# UNITED STATES PATENT AND TRADEMARK OFFICE

APPLICATION NO.	FILING DATE	FIRST NAMED INVENTOR	ATTORNEY DOCKET NO.	CONFIRMATION NO.
10/810,709	03/29/2004	Hirota Fukushima	ED-US020437	9049

<b>Office Action Summary</b>	Application No.	Applicant(s)	
	10/810,709	FUKUSHIMA, HIROTAKA	
	Examiner	Art Unit	
	Saúl J. Rodríguez	3681

## **DETAILED ACTION**

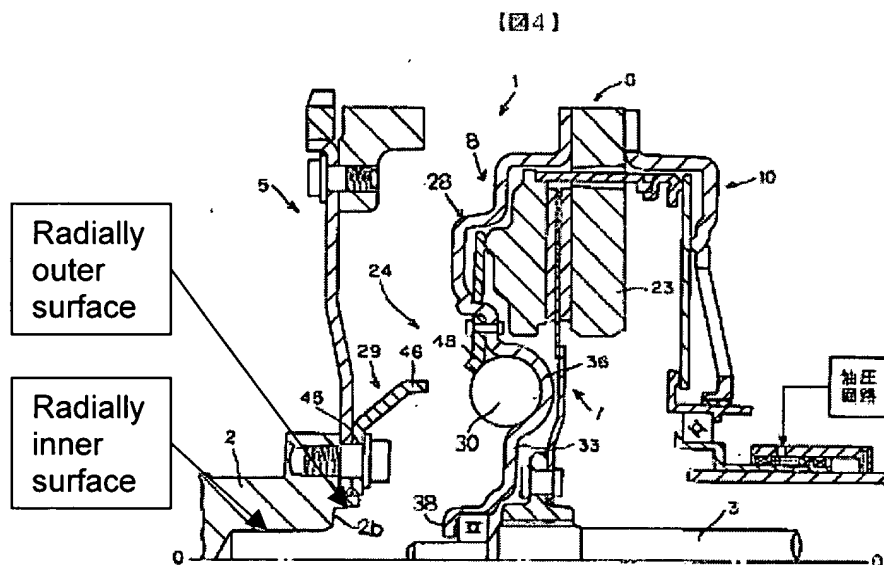
JP discloses a flywheel assembly (Fig. 4) comprising a flywheel (23), a damper mechanism (30), a support member (5), a radially inner surface for receiving the input shaft of the transmission, a radially outer surface for axially and radially supporting the flywheel (38), a plurality of axially and radially extending portions (29), an axial gap, a crankshaft side member, and support members (33, 43).

Applicant's arguments filed May 11, 2006 have been fully considered but they are not persuasive. Concerning applicant's argument regarding claim 1, the examiner submits that the prior art discloses a radially inner and outer surfaces. Please refer to the provided clarification of the figure. As a result, the rejection is deemed proper.
